ADDENDUM TO THE CONTRACT

Mendenhall Valley Public Library
Contract No. E14-051

ADDENDUM NO.: SEVEN

DATE ADDENDUM ISSUED: April 1, 2014

LIBRARY 117 - CIRC WEST ELEVATION

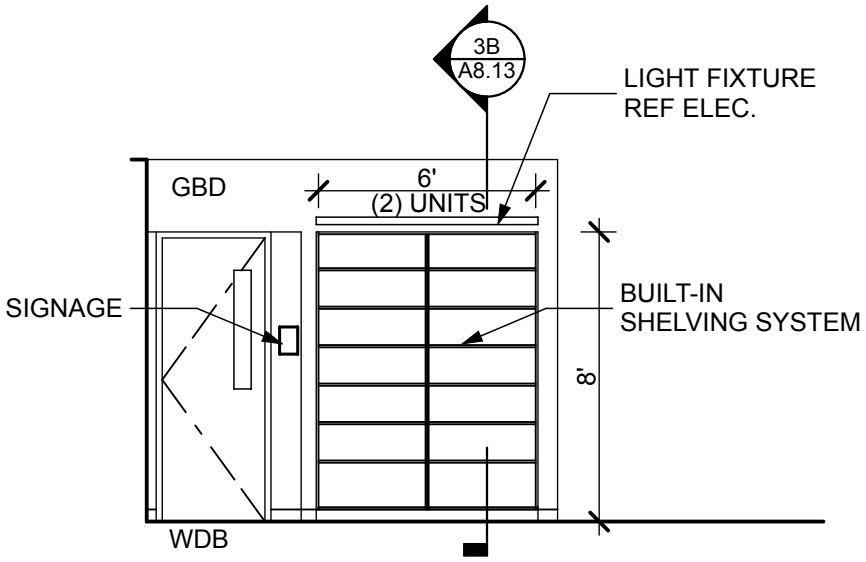
Item No. 11 DRAWING SHEET A6.5 INTERIOR ELEVATIONS, REVISION 2:

Add: INTERIOR ELEVATIONS 117 CIRC. NORTH ELEVATION”, attached.

3B SECTION - BUILT-IN BOOKCASE

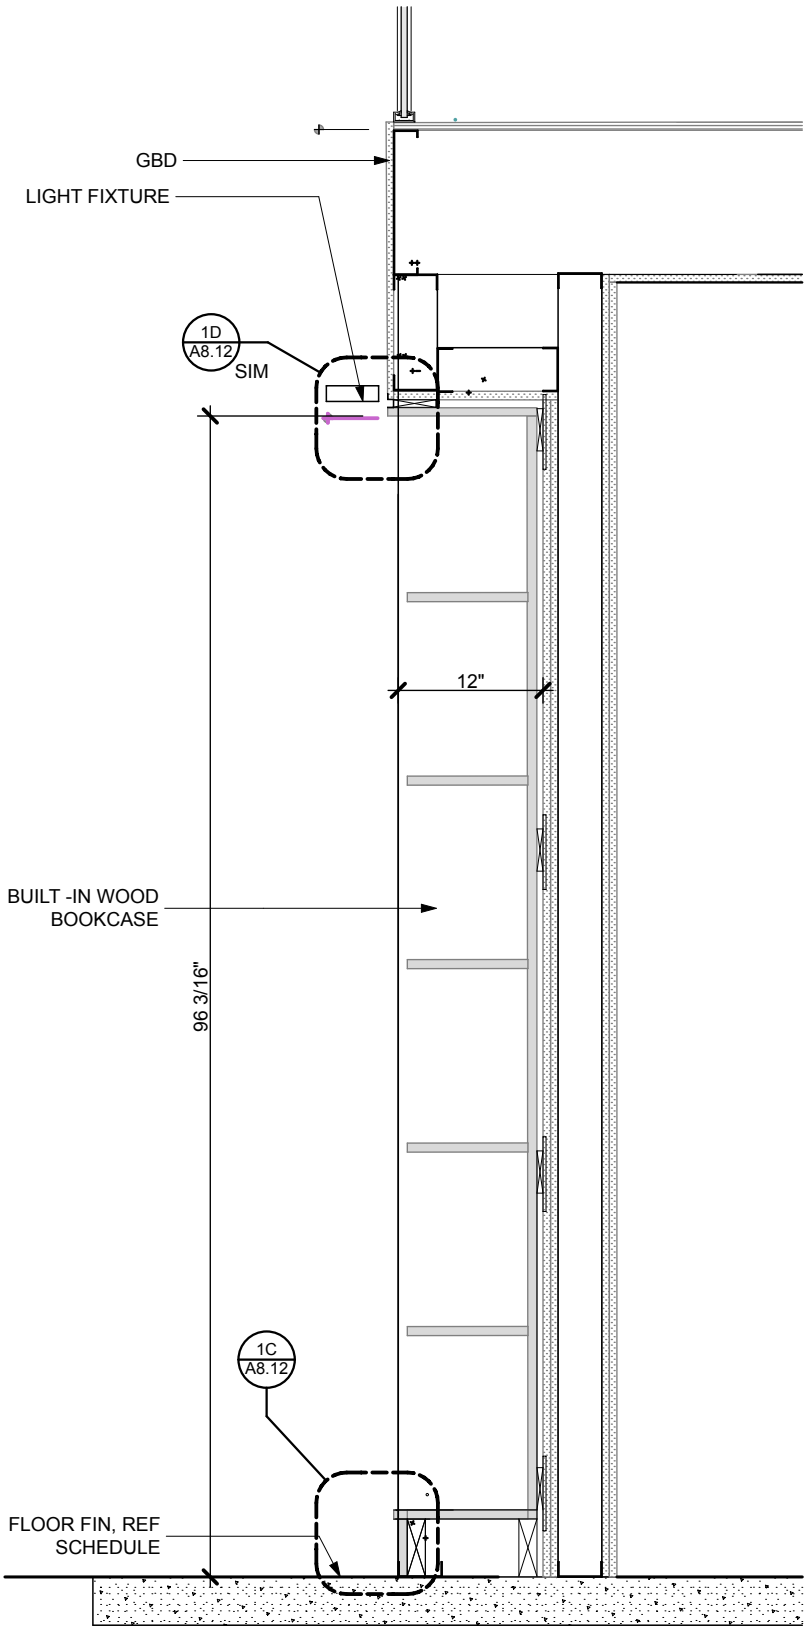
Item No. 12 DRAWING SHEET A8.13, CASEWORK SECTIONS:

Add: 3B/A8.13 detail, attached.

3A STAIR AT SERVICE 105

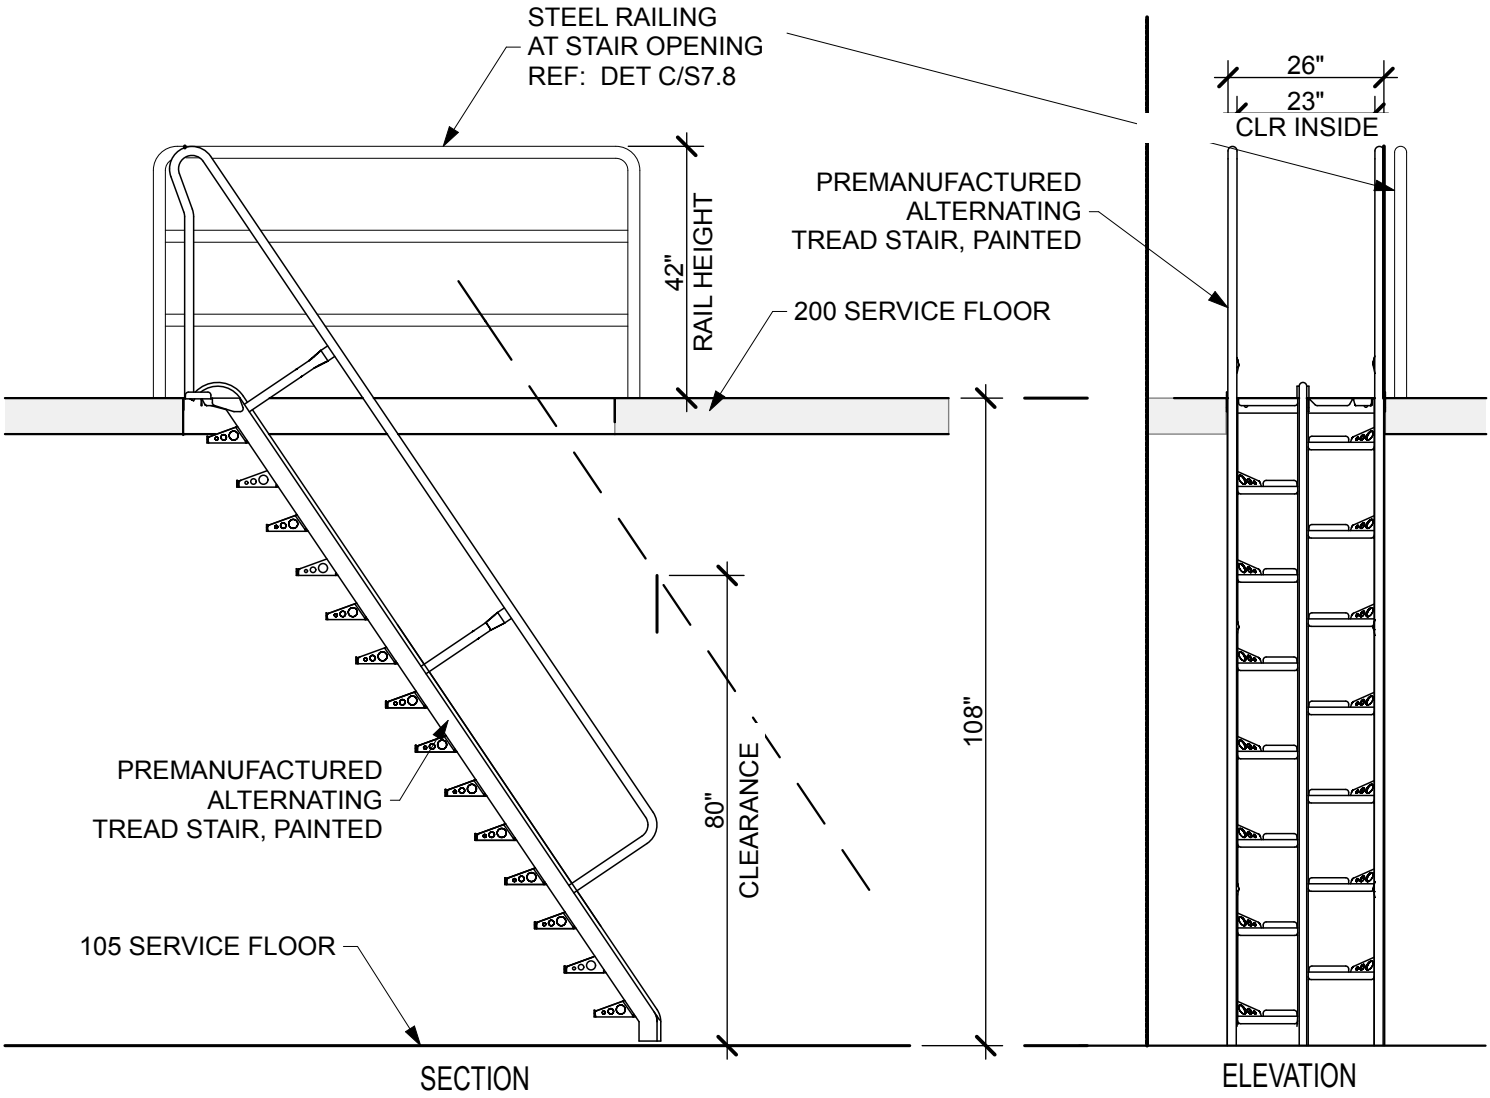
Item No. 13 DRAWING SHEET A8.22 FIREPLACE – ALT 00

Add: Stair at Service 105 detail, attached.
